JC-24x

Version Update

from V 3.25 to V 3.26

Revision 1.01

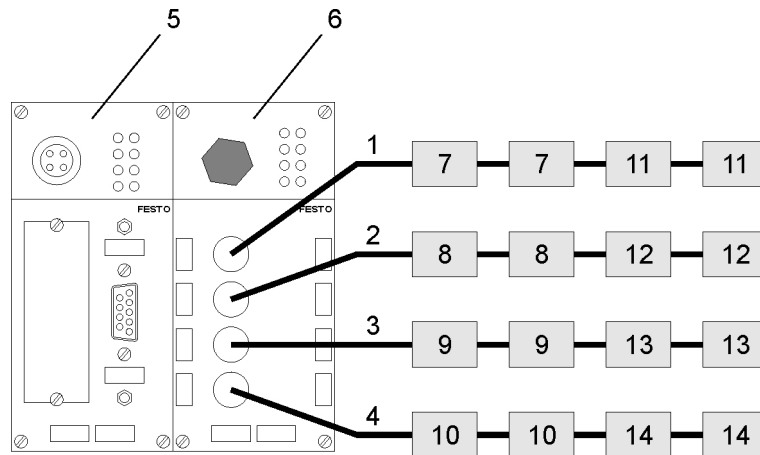
At applying the CPX-CPI interface, the number of the analog inputs and outputs to be connected is reduced.

If at the CP string 1 or 2 ...	Then the number of ...
CP / CPI output modules are connected,	the analog outputs is reduced to 8
CP valve terminals are connected,	the analog outputs is reduced to 8
CP / CPI input modules are connected,	the analog inputs is reduced to 8

If at the CP string 3 or 4 ...	Then the number of ...
CP / CPI output modules are connected,	the analog outputs is reduced to 4
CP valve terminals are connected,	the analog outputs is reduced to 4
CP / CPI input modules are connected,	the analog inputs is reduced to 4
